North East Link Tunnels Urban Design and Landscape Plan (UDLP)

Manningham City Council Submission

03 June 2022

Image 1: Indicative Ilma court realignment

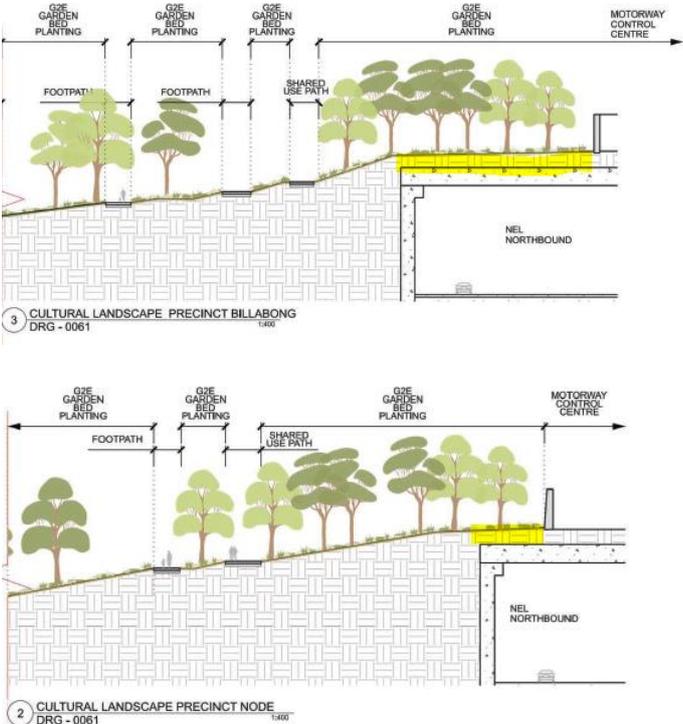
57. Council seeks the realignment of Ilma Court to the existing signalised intersection of Bulleen Rd / Golden Way (image 1).
58. Council considers there is significant merit for this proposal to be implemented as part of the NEL designs, as noted below:

- The Ilma Court / Bulleen Road intersection currently only allows for left in and left out movements, resulting in residents wishing to travel south along Bulleen Road to cross multiple lanes of Bulleen Road traffic to undertake a “U” turn at the Golden Way signals.

- The realignment of Ilma Court with the signalised intersection of Golden Way creates a standard signalised cross intersection. This will allow for all left / right turn movements to occur via traffic signals and improves access arrangements for the Ilma Court / Robb Close residents and removes the need for a “U turn” signal phase.

- A standard cross signalised intersection is unlikely to cause any delays to the Bulleen Road traffic.
 - The new Ilma Court leg can operate in conjunction with the Golden Way signal phasing, thereby not requiring any reduction in traffic throughput on Bulleen Road.

- The proposed road realignment still allows opportunities for the State to redevelop the acquired residential parcels of land.
 - The realignment will improve the safety of all road users by not requiring the Ilma Court traffic to cross over two lanes of Bulleen Road to access the “U” turn opportunity.

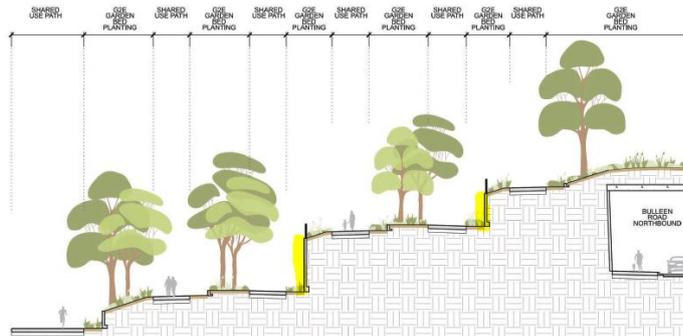
Planting Recommendation	<p>For planting design (along medians, parklands, etc) it is recommended to consider native low maintenance species, complying with CPTED requirements.</p>
Landscape Planting Detail	<p>Further details are required on how planting design varies depending to its function/context (screening, riparian, open views, etc). Further detail should be provided beyond planting palette.</p>
Management of Mature Trees	<p>Further details are requested on how mature trees within the construction area will be managed. It is noted that trees along the boundary will be reinstated where possible, does this apply to other impacted trees within the scope of works?</p>
Soil depth – Tree Planting	<p>Further details are required on the cross sections exhibited in the UDLP. Details are required to specify soil depths to ensure tree</p>

Issue Topic	Comment
	<p>locations are feasible. The below images highlight the areas where this is of particular concern.</p> 
<p>Visual Bulk – Blank Walls</p>	<p>It is recommended that treatments should be provided to reduce the visual bulk of blank walls (incorporating landscape treatment, reducing heights of retaining walls). The below cross section highlights areas of particular concern.</p> 
<p>Further plan details</p>	<p>To better assess the visual impacts of flood walls and noise walls Council requests that levels on the top of the flood walls and noise walls are provided.</p>
